Impedance of new ALICE beam pipe

Benoit Salvant, Rainer Wanzenberg and Olga Zagorodnova

TREX meeting July 31st 2014

ALICE aperture change request

Power from resonant modes

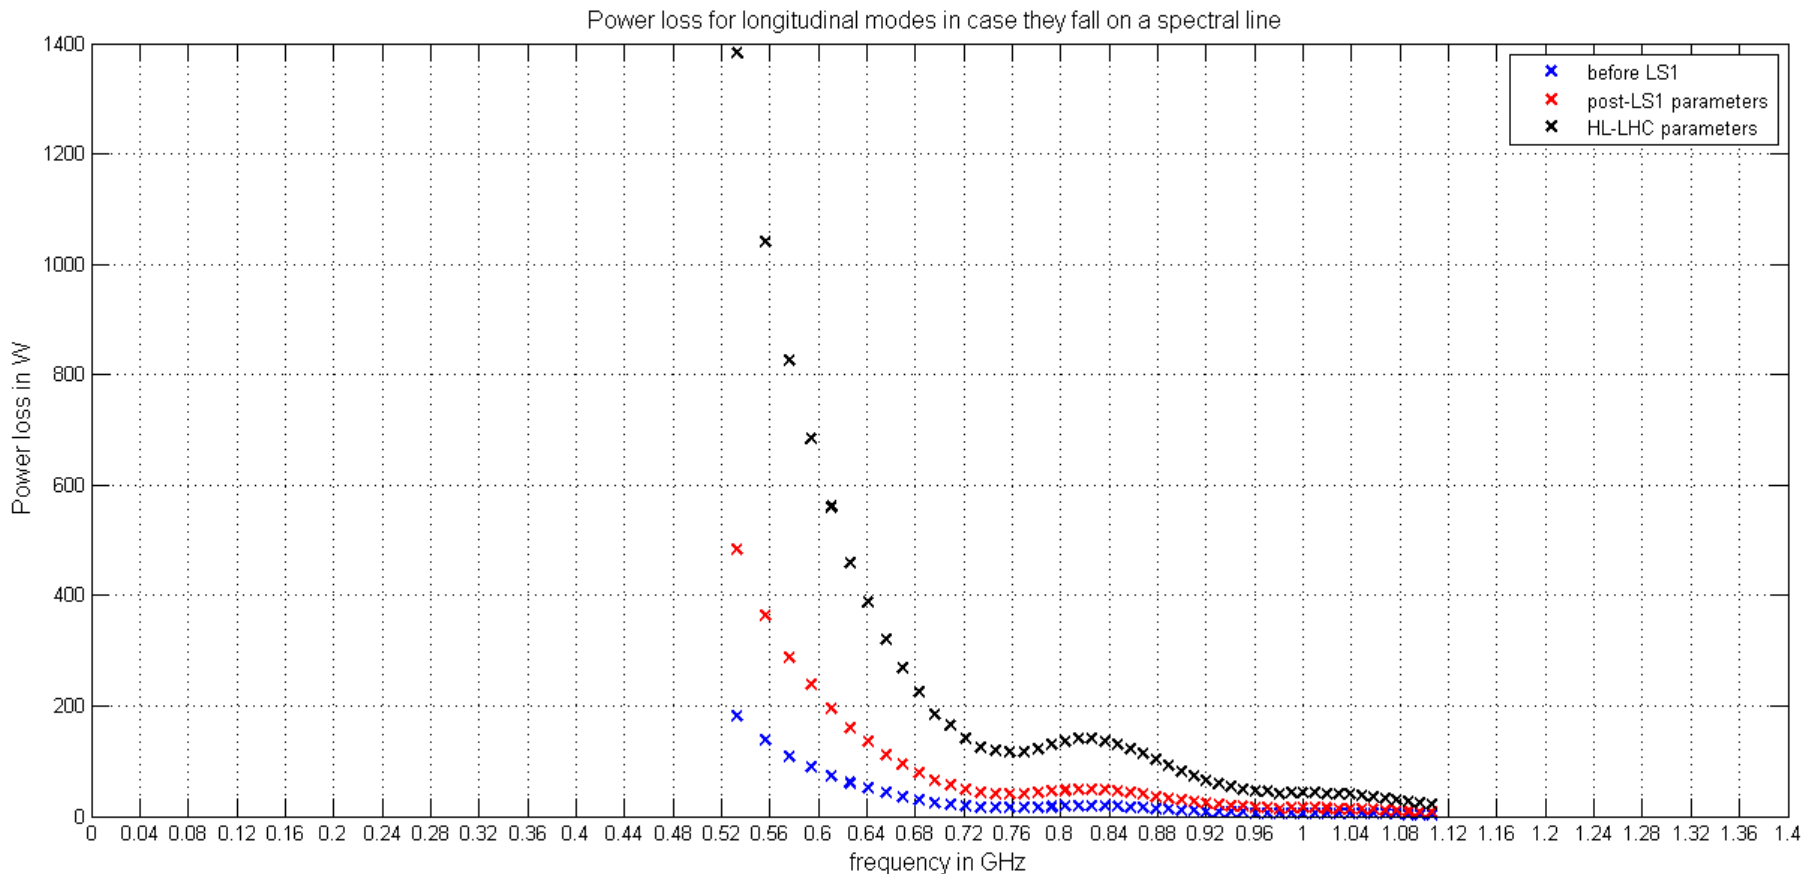
Significant increase of power loss with HL-LHC parameters

→ even the modes at higher frequencies are significant (of the order of 20 to 50 W)

Location of modes?

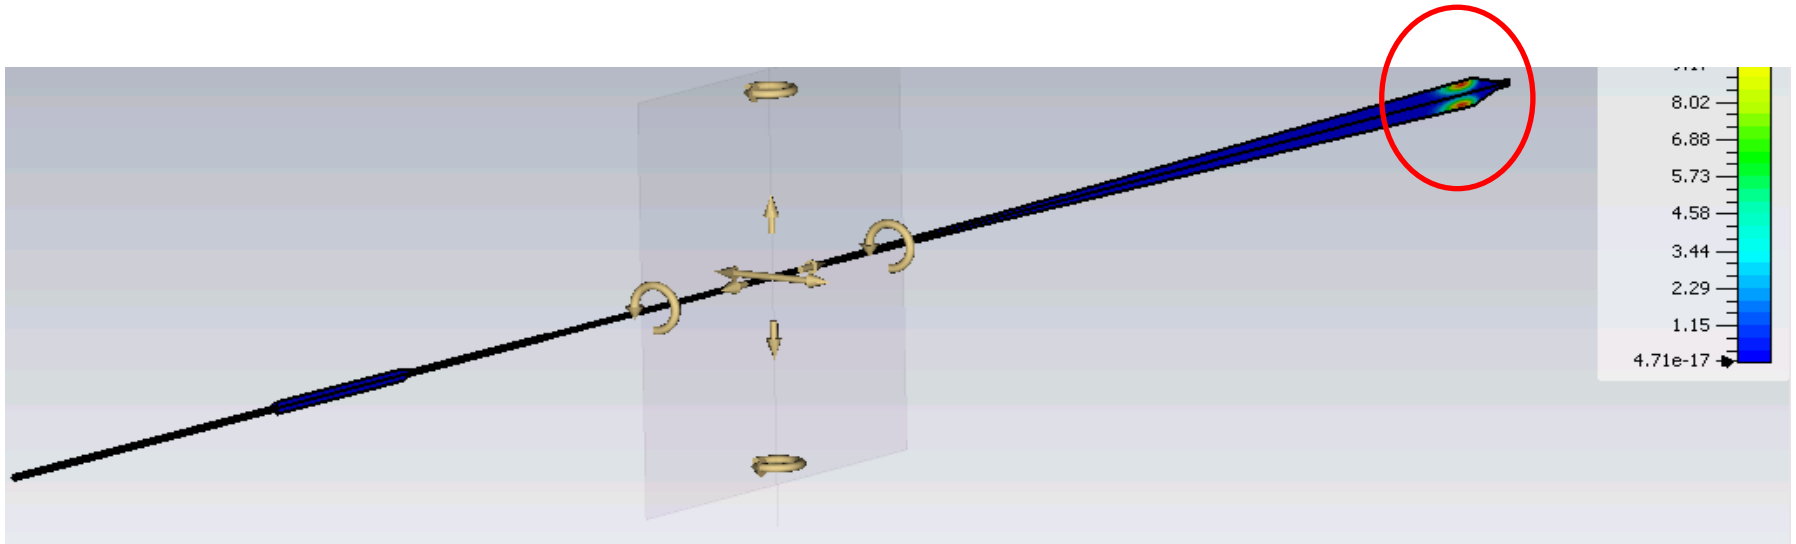
Linked to the large diameter of the cone → localized there

No changes foreseen in this area, so these modes are not affected by the upgrade

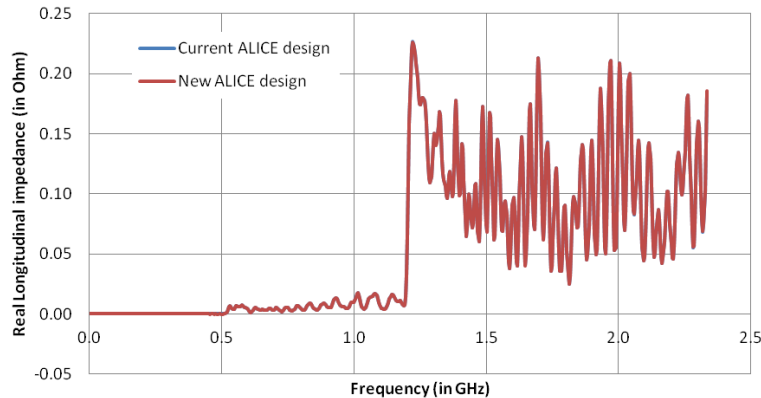
→ significant increase of impedance with the new geometry. However, it remains very small compared to the total LHC impedance. Is a 70% increase in power loss ok?

Comparison of the real longitudinal impedance for the current ALICE chamber and for the new design

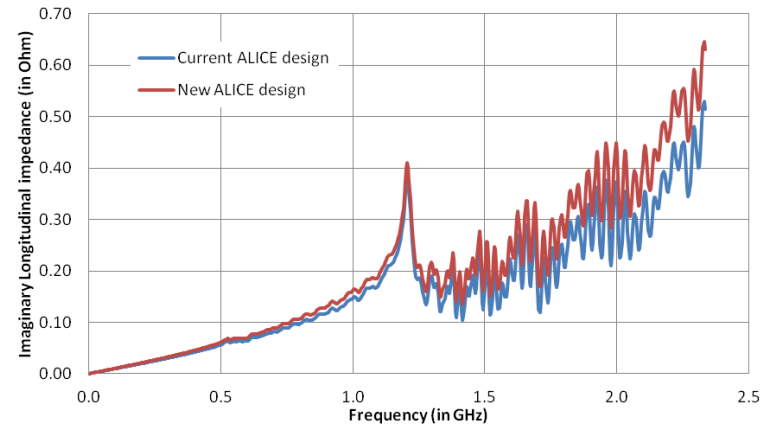
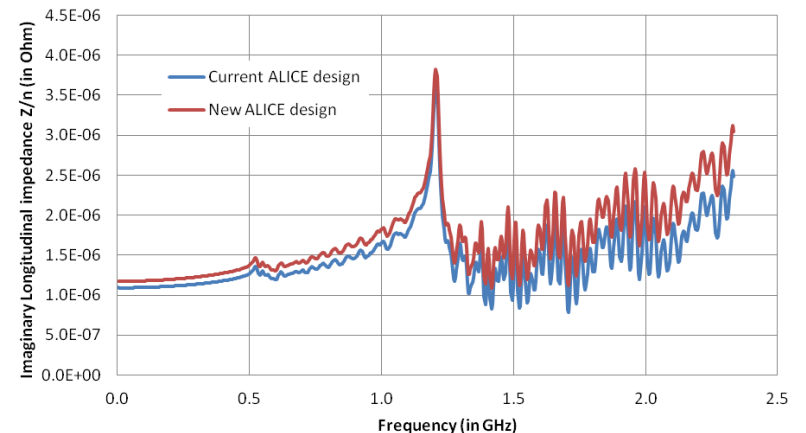
- No measurable difference in the real part of the impedance
- There is an increase of 7% of the imaginary part of the impedance
